Attachment 8 – Engineering

Our reference: 532253

Land Use Consent – Civil RFI Response – RMA/2024/3209

Figure 1 Proposed Layout for assessing wastewater generation.

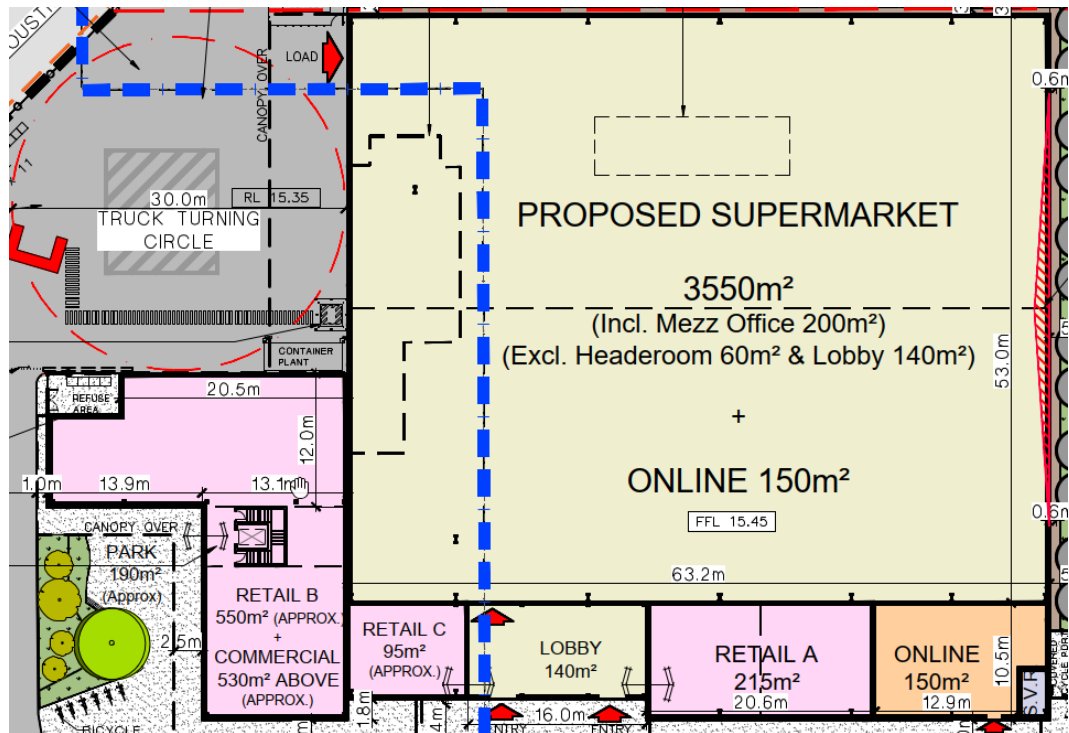
Feedback from Woolworths NZ Ltd.'s internal operations team is that their expected occupancy for the proposed supermarket (to calculate wastewater flow):

There could be between 30-40 staff working in the stores during the busiest hours. WWNZ typically provide 4-6 toilets for staff plus 1-2 shower facilities. WWNZ also provide one accessible toilet for customers - as a ballpark I suggest allowing 10 customer usages / flushes per hour.

To give an indication of the likely wastewater generation for the total site including the supermarket and retail areas we have based our calculations of Discharge Units (in accordance with NZBC G13/AS2) on the following fixtures in each space:

- Supermarket – 5 staff toilets with basin, 2 showers, 1 accessible customer toilet with basin.
- Retail spaces A & C – For each space: 2 x staff toilets with basin, 1 x kitchen with sink and dishwasher.
- Retail space B and commercial space above – For each space: 4 staff toilets with basins, 1 customer toilet with basin, 2 showers.
- We have assumed that one of the tenancies will be either a café or bar with a kitchen (i.e. sink, dishwasher, glass washer, coffee machine, drinking fountain).

Total Discharge Units (in accordance with NZBC G13/AS2) is 173Dus. For comparison this is approximately equivalent to 6 residential dwellings with kitchen, laundry, bathroom, ensuite, separate toilet.
